# TECHNICAL BULLETIN

## Solid State Relays(SSRs) 1.3751

T16.005

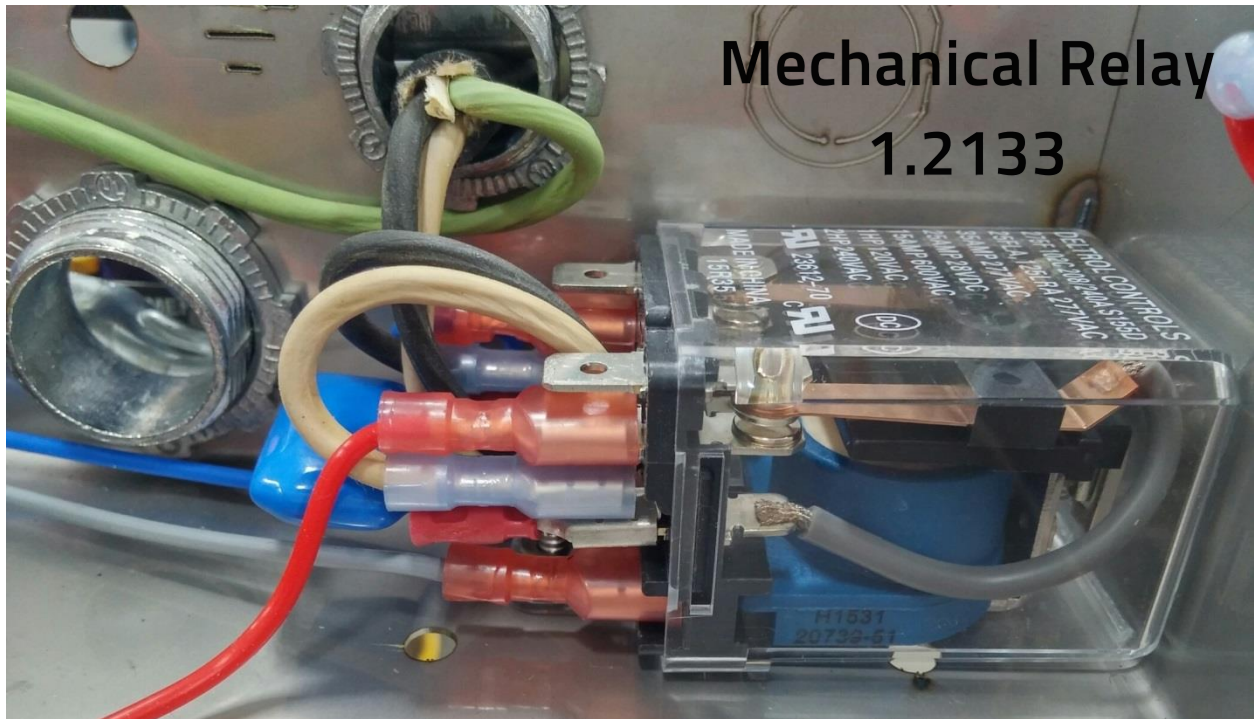
Electrical noise created by some mechanical relays was causing some second generation and MVP style machines to reboot. This issue could cause the shot timers to either go blank, or fully illuminate. Replacing all mechanical relays (1.2133) with SSRs (1.3751) has prevented further reboots.

All new production machines will be built with SSRs standard. Any second generation or later machine having the shot timer issues described above should have the mechanical relay replaced. Many machines do not show any problems with the mechanical relays and therefore do not require service.

While the mechanical relays broke both sides of the 220v circuit which powers the pump motor, the SSRs break only the "red" side of the circuit. Please turn off the machine any time you must service the motor's electrical system, especially if you use split phase power (2x 110v hot legs as used in much of North America).

The SSRs use a screw terminal electrical interface as opposed to the 0.25" quick-connect terminals used on the mechanical relays. As such, when replacing a mechanical relay, have ring terminals or new wires available.

Solid State  
Relay  
1.3751

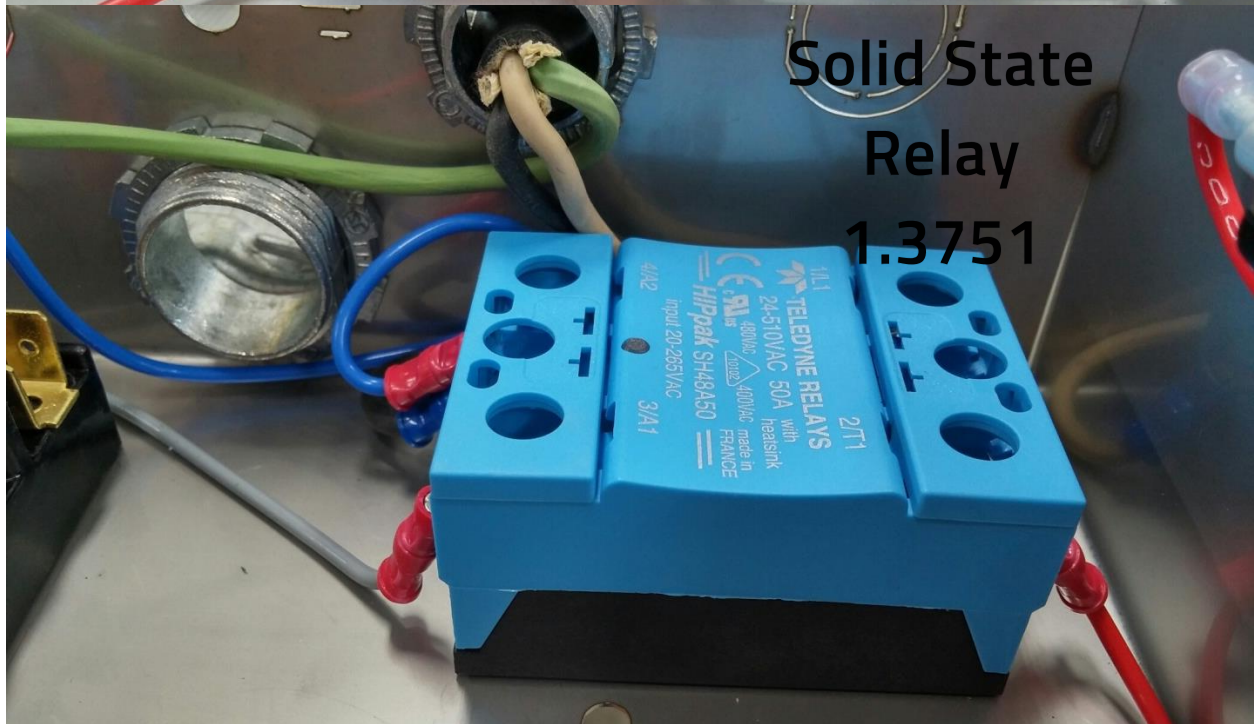
We will no longer build machines using mechanical relays, but we will have them available for parts orders. First generation machines and others showing no problems requiring SSRs may continue to use mechanical relays as needed.
